CHESTERFIELD PLACE SUBDIVISION, **RESUBDIVISION OF LOT 11**

APPLICATION NUMBER 23 DATE March 20, 2008
APPLICANT Chesterfield Place Subdivision, Resubdivision of Lot 11
REQUEST Subdivision

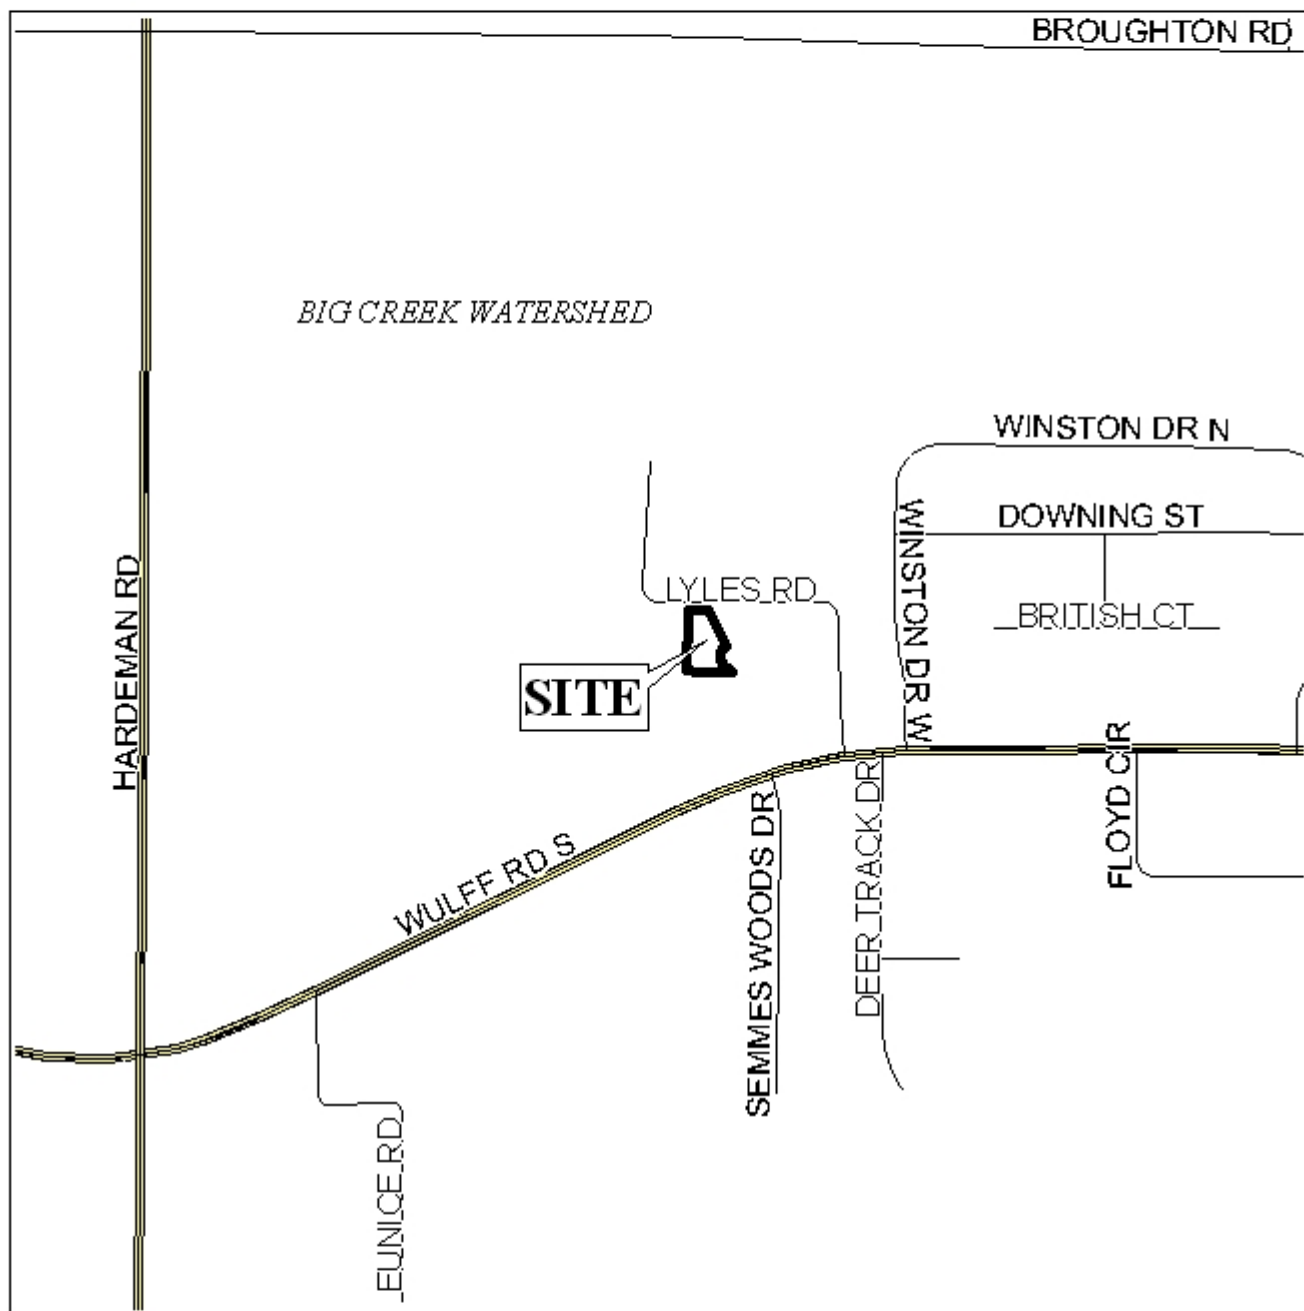
The lot sizes in square feet and acreage are indicated on the plat. The lot sizes in square feet, at a minimum, should also be depicted on the final plat, or a table provided furnishing the same information, if approved.

- 3) labeling of each lot with its size in square feet;
- 4) Placement of a note on the final plat stating that any lots which are developed commercially and adjoin residentially developed property must provide a buffer, in compliance with Section V.A.7 of the Subdivision Regulations;
